US Army Corps  
Of Engineers  
Wilmington District

# PUBLIC NOTICE

Issue Date: September 27, 2021  
Comment Deadline: October 12, 2021  
Corps Action ID Number: SAW-2019-01155

Town of Sunset Beach Navigation Project  
Bay Area Realignment & Temporary Bulkhead  
Project Narrative  
August 17, 2021

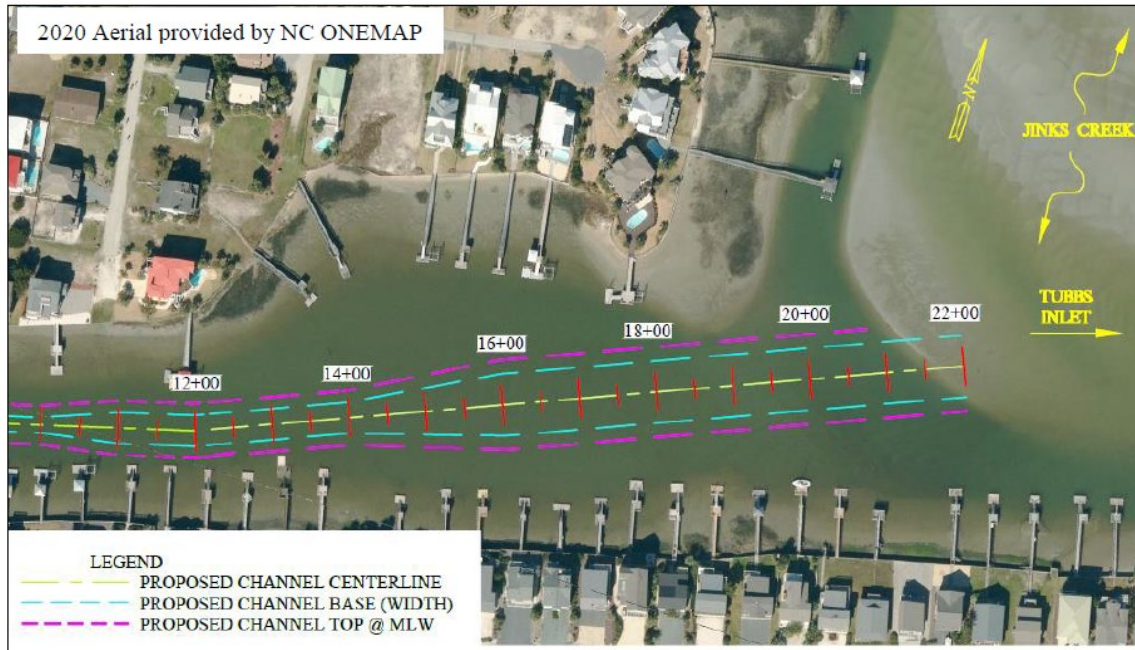
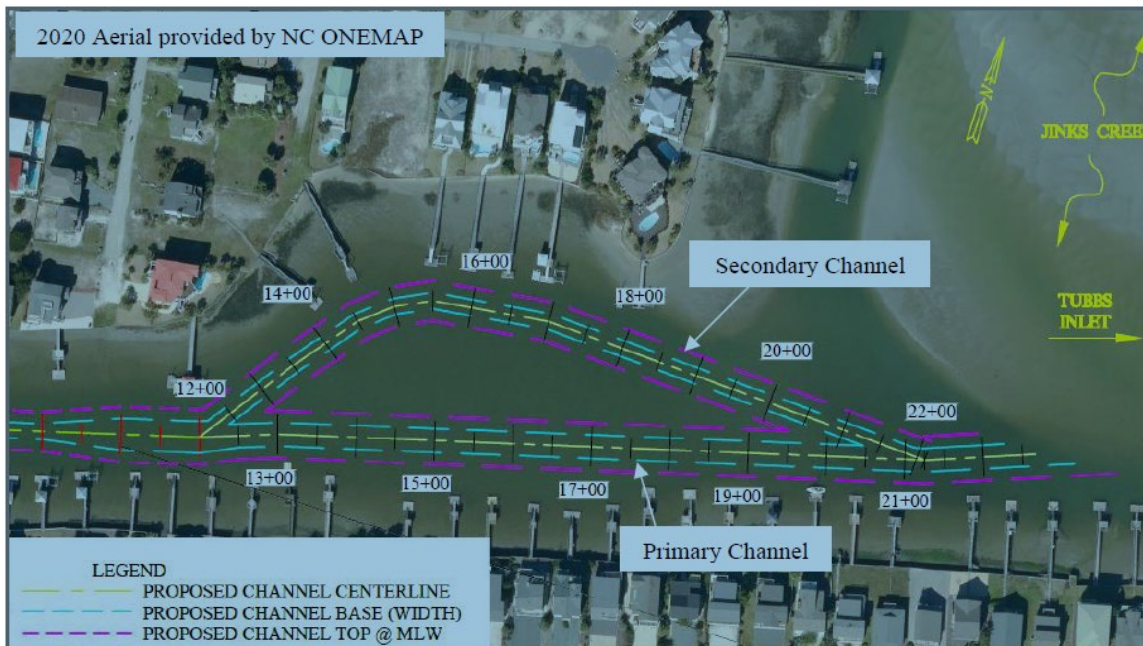
The currently permitted dredge template for the Bay Area currently extends through the approximate middle of the water body and terminates at the south Jinks Creek confluence with an 80-ft width. The modification request realigns the channel terminus from one (1) wide channel to two (2) narrower channels comprising a primary and secondary navigation route. The primary channel extends along the southern Bay Area shoreline and maintains a 50-ft to 55-ft width (top cut), while the secondary channel follows the northern shoreline at a 40-ft to 45-ft width (top cut). The maximum dredge depth remains -6-ft MLW (-5+1) with 3:1 channel side slopes. Similar to the original alignment, the average depth in the Bay Area system will be increased from approximately -2-ft to -3-ft MLW to -6-ft (-5+1) MLW.

Figure 2 shows a plan view comparison of the currently permitted alignment and the proposed realignment for the Bay Area and Tab E attachment provides the permit design drawings. The realignment extends the Bay Area primary channel by approximately 200-ft by following the southern shoreline until the template joins with south Jinks Creek. Overall, the realignment initiates at station 12+00 from the original template and terminates at approximate station 24+00 at the south Jinks Creek confluence. The impact area for the original alignment equaled approximately 2.0 acres (86,277-ft<sup>2</sup>) and the realigned channel covers approximately 2.3 acres (101,176 ft<sup>2</sup>), inclusive of both the primary and secondary channels. The dredge volume would increase from 12,200 CY (original channel) to 16,894 CY with the new alignment.

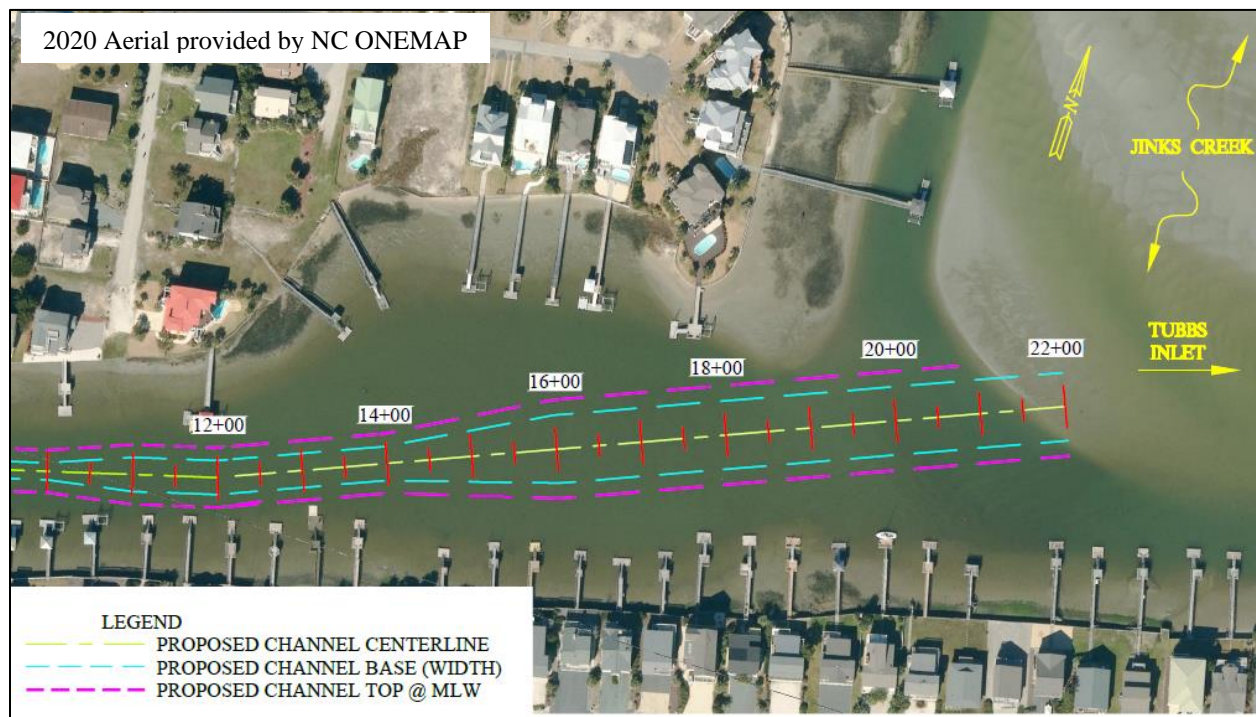
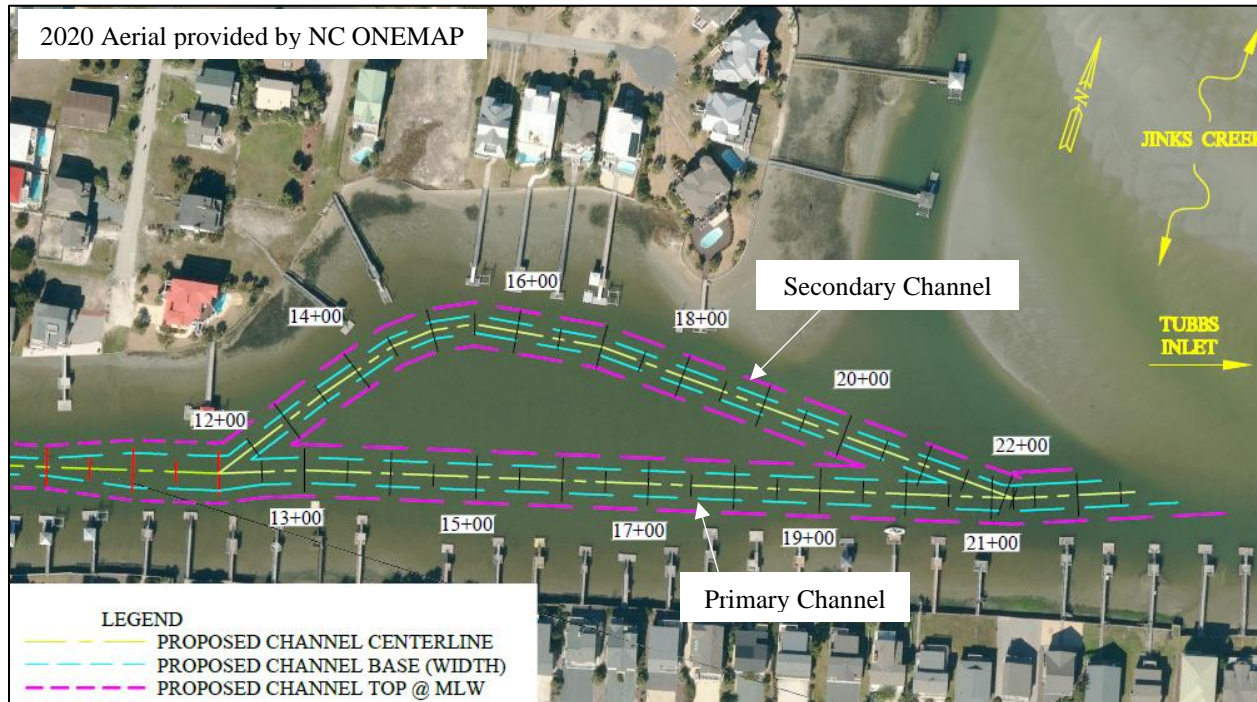
The currently permitted dredge template for the Bay Area currently extends through the approximate middle of the water body and terminates at the south Jinks Creek confluence with an 80-ft width. The modification request realigns the channel terminus from one (1) wide channel to two (2) narrower channels comprising of a primary and secondary navigation route. The primary channel extends along the southern Bay Area shoreline and maintains a 50-ft to 55-ft width (top cut), while the secondary channel follows the northern shoreline at a 40-ft to 45-ft width (top cut). The maximum dredge depth remains -6-ft MLW (-5+1) with 3:1 channel side slopes. Similar to the original alignment, the average depth in the Bay Area system will be increased from approximately -2-ft to -3-ft MLW to -6-ft (-5+1) MLW.

Figure 2 shows a plan view comparison of the currently permitted alignment and the proposed realignment for the Bay Area and Tab E provides the permit drawings. The realignment extends the Bay Area primary channel by approximately 200-ft by following the southern shoreline until the template joins with south Jinks Creek. Overall, the realignment initiates at station 12+00 from the original template and terminates at approximate station 24+00 in the south Jinks Creek confluence. The impact area for the original alignment equaled approximately 2.0 acres (86,277-ft<sup>2</sup>) and the realigned channel covers approximately 2.3 acres (101,176 ft<sup>2</sup>), inclusive of both the primary and secondary channels. As shown above, the dredge volume increased from 12,200 CY (original channel) to 16,894 CY with the new alignment.
